NAME	EE-2318V (9P)	MATERIAL	PM-9820	SCALE	1:1	ANGLE	±1°
DRAWING NO.	HX 2302	PIN MATERIAL	CP WIRE	UNIT	m/m	REV.	03
东莞市华欣塑胶制品有限公司 DONGGUAN HUAXIN PLASTIC MANUFACTURING PRODUCTS CO., LTD. TEL: 0769-86388088 86388188 86388288 FAX: 0769-86388111 http://www.hxbobbin.com E-Mail: hxbobbin@vip.163.com		TOLERANCE OF PIN DIA ±0.05 PIN TENSION LOAD 1.0 kg MIN TOLERANCE: 0<L<4: ±0.1 4<L<16: ±0.2 16<L<63: ±0.3		UL REC. :94V0			
DRAWN & DRAFTED BY		LIN HUA JING		CHECKED & APPROVED BY		DATE: OCT 08 2012

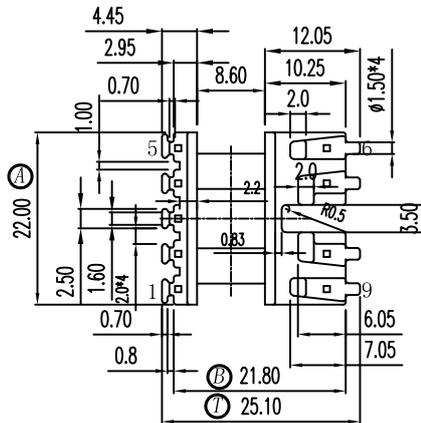
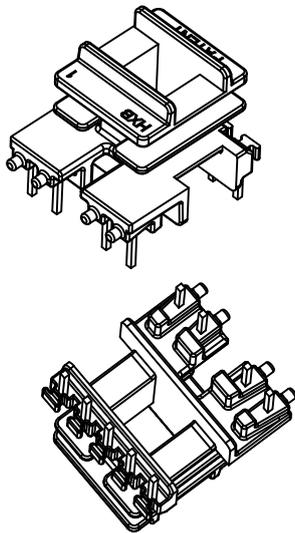
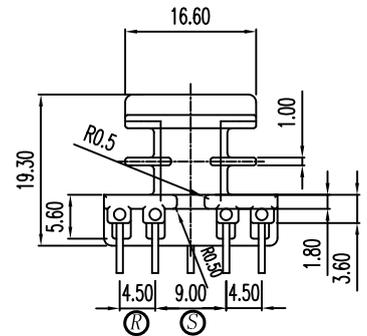
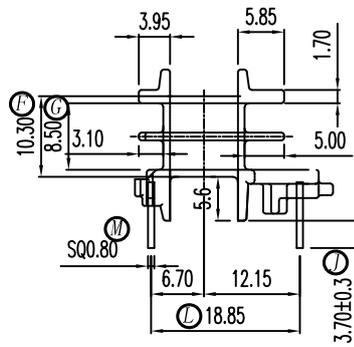
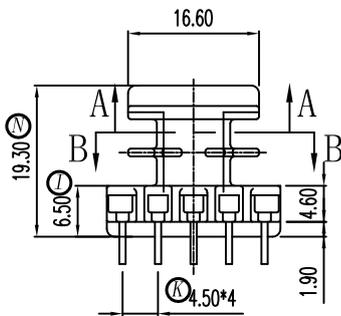
REV.	REVISION RECORD	DATE	REV	REVISION RECORD	DATE
01	1. PIN7, 8BASE凸點離PIN針距離由0.86改為1.20(mm)	2012/10/08	03	1. 按客戶要求紅色尺寸變更	2013/07/25
02	1. 4個PIN邊T型過線槽改為直過線槽底部周邊R角0.30改為0.50,	2013/02/25	04
